USB Cabin Power Interface for NAV III Option Airplanes

ICA Supplement

MODEL NO: 206

SUPPLEMENT NO: ICA-206-24-00001
SUPPLEMENT DATE: 12/23/2020

Cabin Power Interface
Figure 101 (Sheet 2)

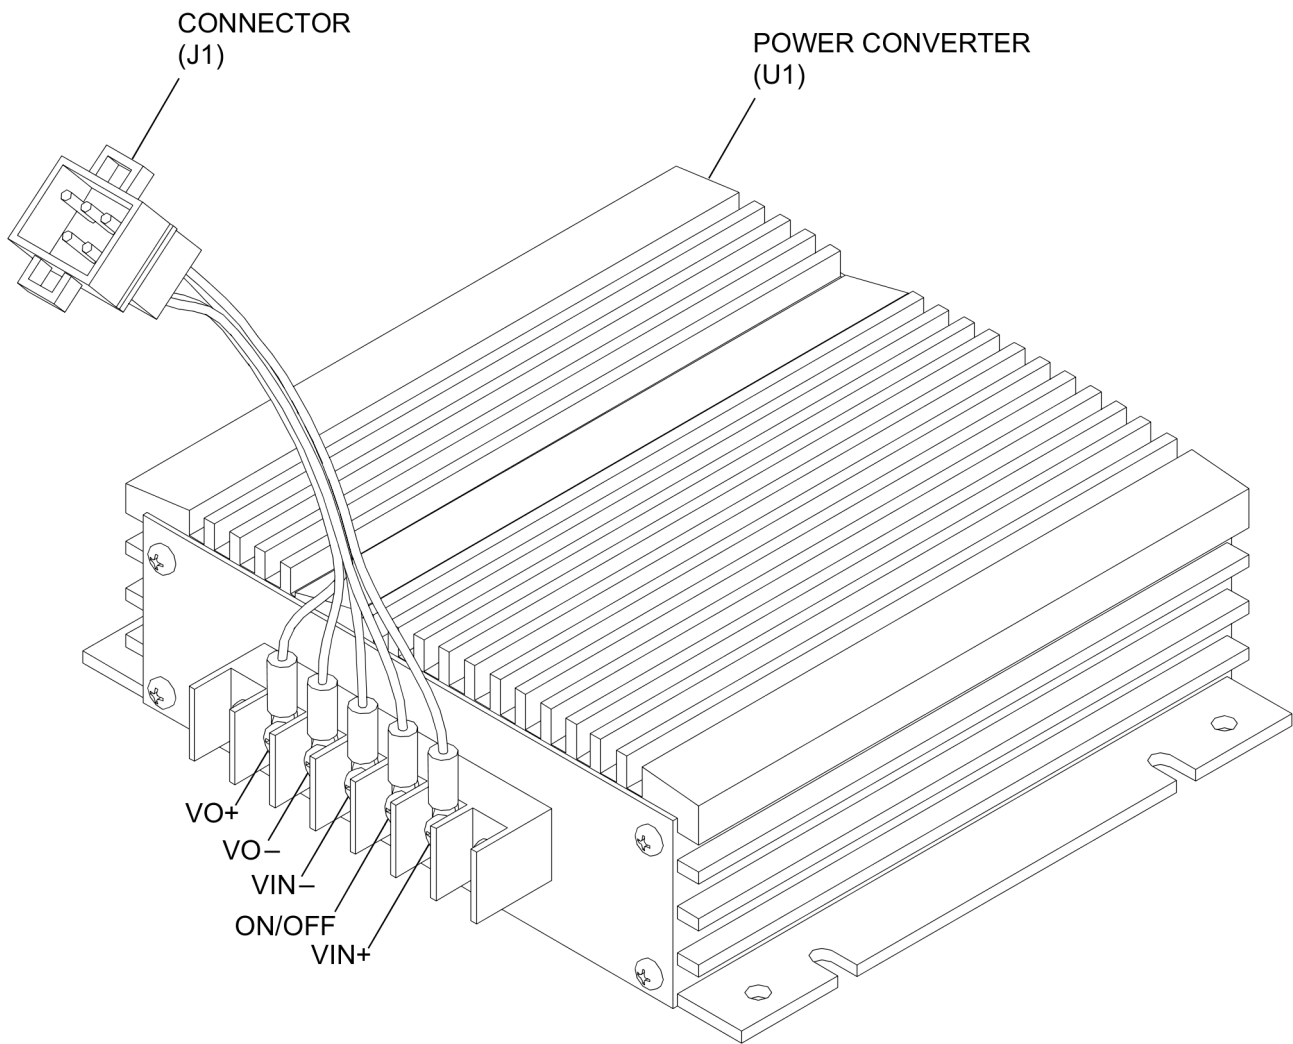
- C. Airplanes T20609622 and On with the NAV III option have a USB cabin power interface installed in the pedestal in place of the 12-Volt cabin power interface. The USB interface is a self-contained, DC-DC power converter with USB type A and type C outlets that are used to supply USB compatible electronic devices with power. The USB power interface obtains 28 VDC of current through the CABIN LTS/PWR (HI056) circuit breaker and does not connect directly to the power converter.

- A. Remove the USB Cabin Power Interface (Refer to Figure 101).
 - (1) Get access to the USB Cabin Power Interface wire bundle. Remove the pedestal cover assembly. Refer to Chapter 25, Interior Upholstery - Maintenance Practices.

- B. Install the USB Cabin Power Interface (Refer to Figure 101).
- (1) Put the USB Cabin Power Interface in its place on the pedestal cover assembly.
 - (2) Install the screws that secure the USB Cabin Power Interface to the pedestal cover assembly.

POWER INTERFACE
 Figure 05 (Sheet 1)

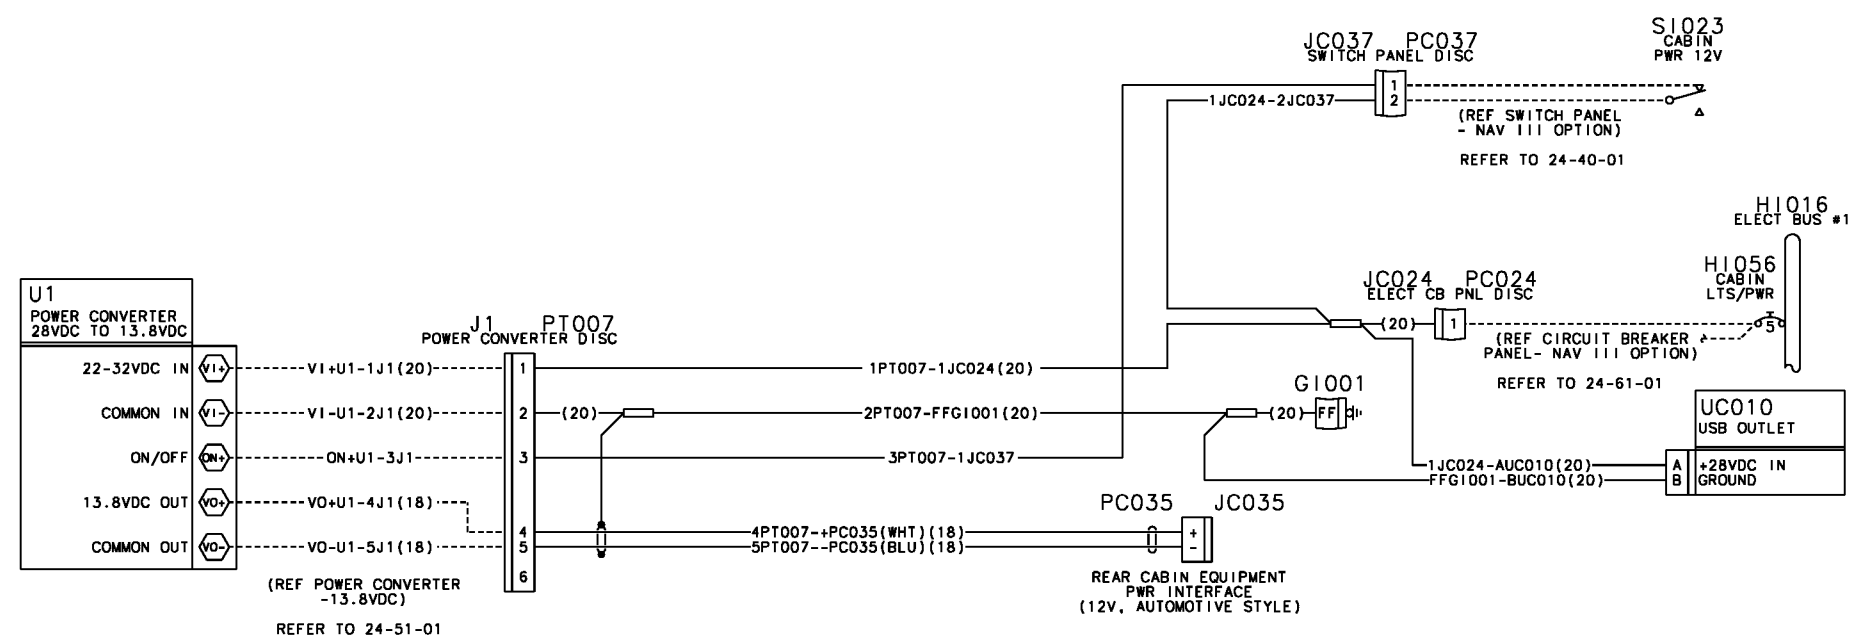
ICA-206-24-00001	Rev: -	Date: Dec 23, 2020
ICA Summary	Pages 1-6	
Manuals Affected	Description	Title
Maintenance Manual	24-60-02 pages 101-107	12-Volt Cabin Power System
<ul style="list-style-type: none"> Added description, removal/installation, adjustment/test, and troubleshooting procedures for the new USB cabin power interface for NAV III Option Airplanes. 		
Appendix A: Illustrated Parts Catalog	See Appendix A	See Attached Parts Table.
Appendix B: Wiring Diagram Manual	24-50-01 Figure 05 pages 1-3	See Attached Wiring Diagram.

- A. Chapter 24 - Electrical Power
(1) Refer to Appendix B, 24-50-01 Figure 05 - Power Interface, T2069622 and On, With NAV III Option wiring diagram.
